Selwyn Terrace

TECHNICAL DATA SHEET FROM REZONING PETITION #02-143

SUBJECT: Administrative Approval for Petition 2002-143, The Boulevard Company (Selwyn Terrace)

RE: Selwyn Terrace Development / Acceptance of Improvements in Side Yard

LAYOUT AND LANDSCAPE PLAN

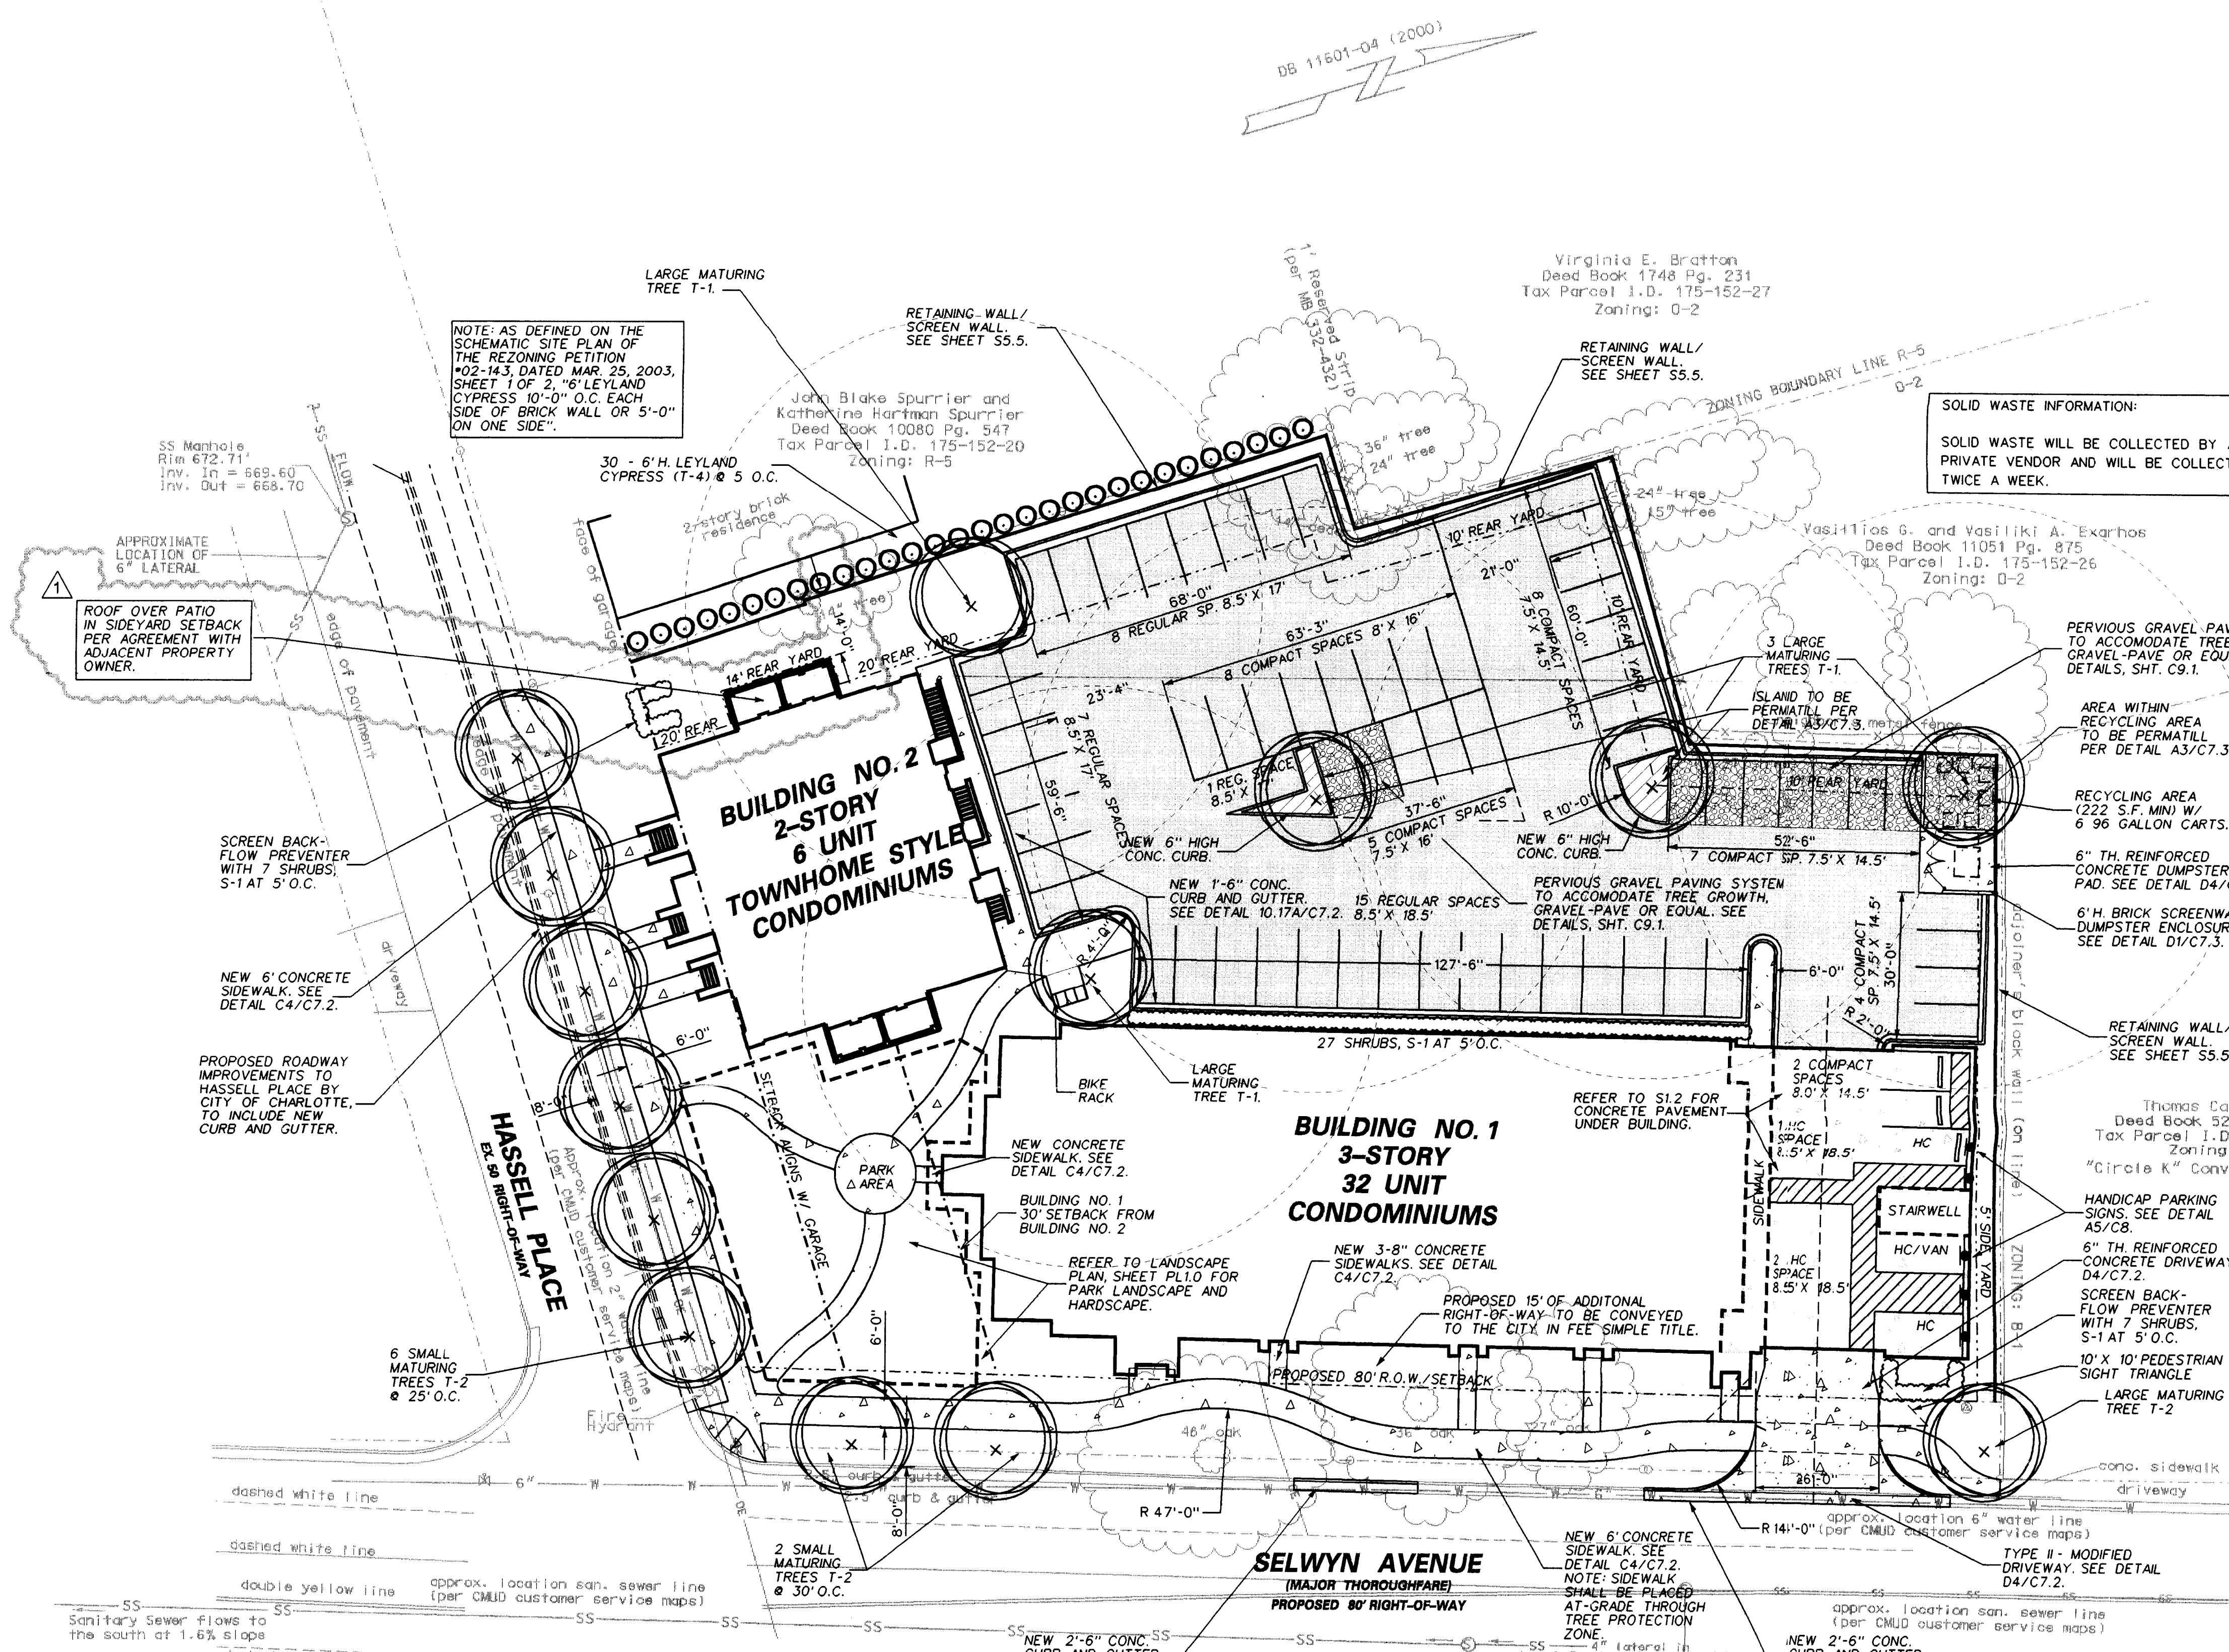
Attached is a copy of a revised site plan for the above referenced rezoning petition located on the corner of Selwyn Avenue and Hassell Place (tax parcel 175-152-21). Also attached is a letter of approval from the adjacent property owners affected by this modification. The amendment is to allow a 6' encroachment into the 20' rear yard as labeled on the original conditional plan for a covered patio.

The Boulevard Company's condominium development, Selwyn Terrace, located on the corner of Selwyn Avenue and Hassell Place, entails the construction of a patio in the side yard of the building fronting Hassell Place. At the time of the property's rezoning, a roof over the patio was not allowed due to its proximity to our property. However, both we and The Boulevard Company find the addition of a roof, as shown on the enclosed elevation, to be beneficial to the development and neighborhood.

This letter serves as confirmation of our acceptance of the construction of the patio roof as shown on the right of the enclosed elevation.

Since these changes are allowed according to section 6.206 of the City Zoning Ordinance, I am administratively approving this revised plan. Please use this revised plan when evaluating requests for building permits and certificates of occupancy.
